**STAFF RECOMMENDATION**  
**2803 Natchez Trace**  
**November 18, 2015**

**Application:** New construction – addition; Setback determination  
**District:** Hillsboro-West End Neighborhood Conservation Zoning Overlay  
**Council District:** 18  
**Map and Parcel Number:** 11702003900  
**Applicant:** Van Mol Restoration LLC  
**Project Lead:** Melissa Sajid, [melissa.sajid@nashville.gov](mailto:melissa.sajid@nashville.gov)

<p><b>Description of Project:</b> The application is for a rear screened porch addition to the house. The request includes a rear setback determination due to a truncated lot.</p> <p><b>Recommendation Summary:</b> Staff recommends approval with the condition that staff approves the roofing color, screening and doors prior to purchase and installation.</p> <p>Staff finds that the project meets the design guidelines for the Hillsboro-West End Neighborhood Conservation Zoning Overlay.</p>	<p><b>Attachments</b> <b>A:</b> Photographs <b>B:</b> Public Comment <b>C:</b> Site Plan <b>D:</b> Elevations</p>
--	---

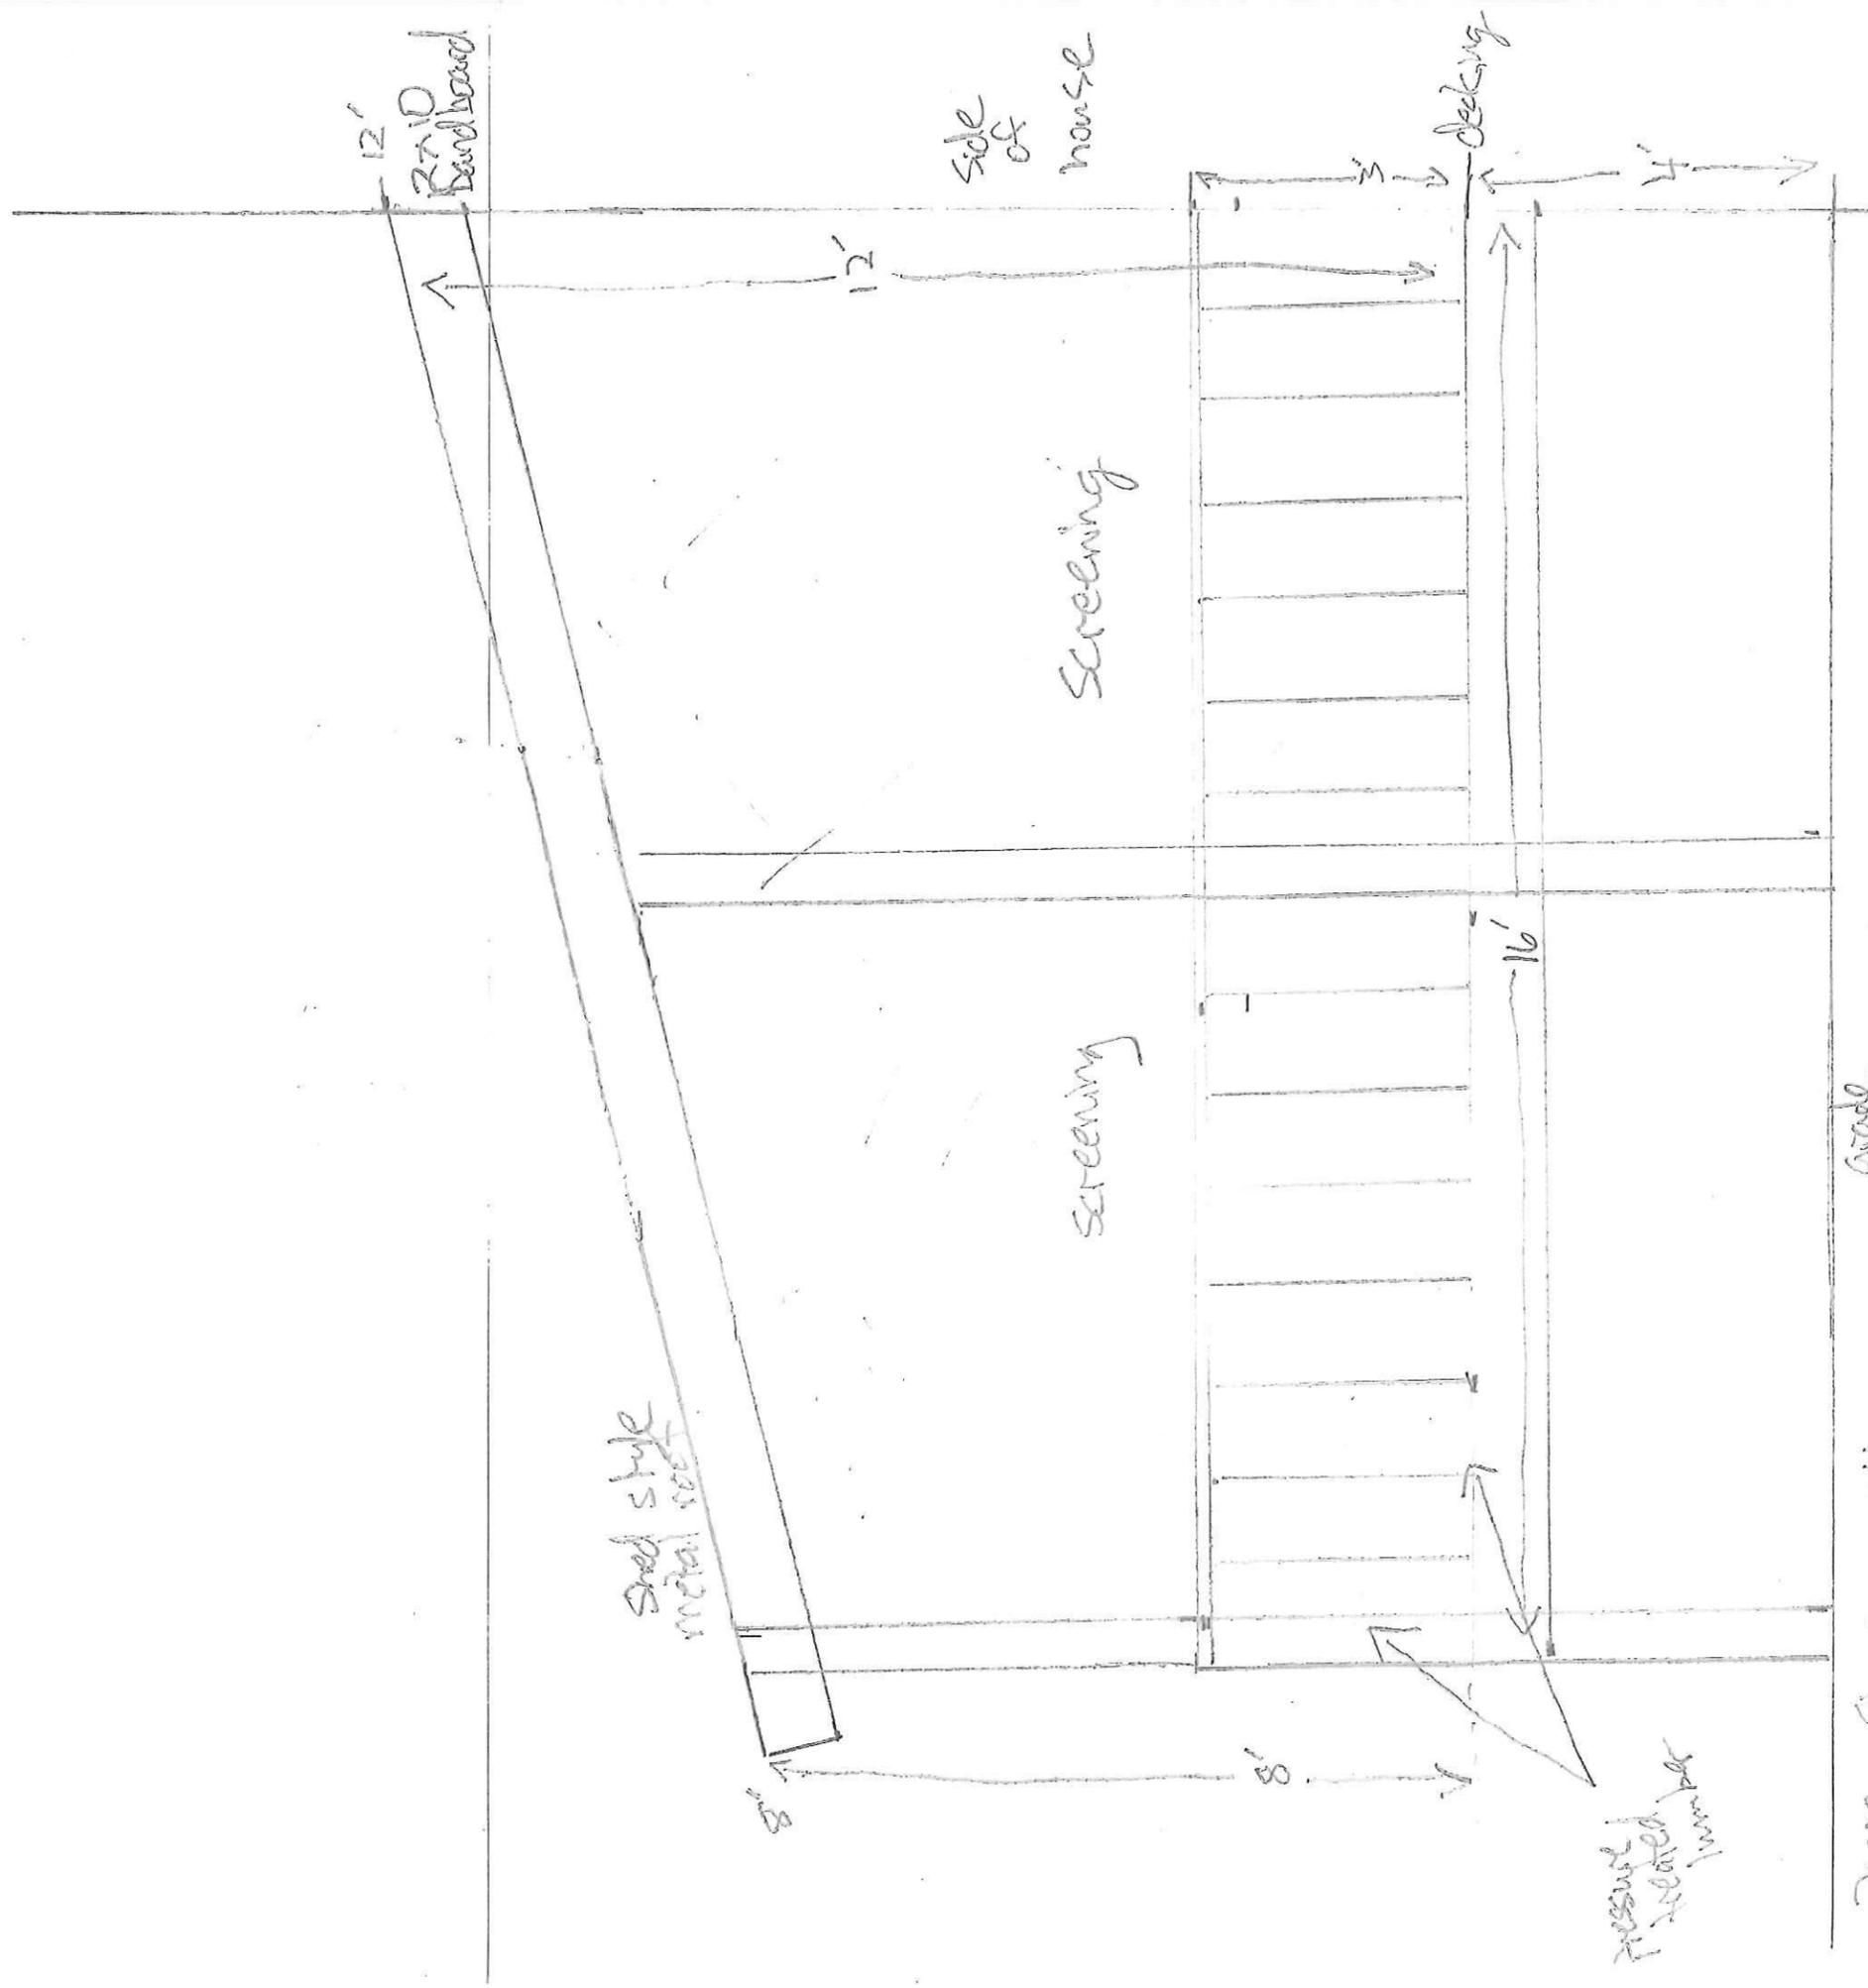
Setback & Rhythm of Spacing: The addition will be narrower than the house, with side setbacks of six feet (6') and fifteen feet (15'). The rear setback will be nine feet (9'). The plan meets the required side setbacks of five feet (5') but does not meet the required rear setback of twenty feet (20'). The applicant has requested a rear setback determination for the rear setback. Staff finds that the request to reduce the rear setback to nine feet (9') is appropriate as a significant portion of the rear yard was taken for the construction of I-440. The loss of part of the rear yard makes it difficult to meet the required twenty feet (20') rear setback. Staff finds that the project meets section II.B.1.c.
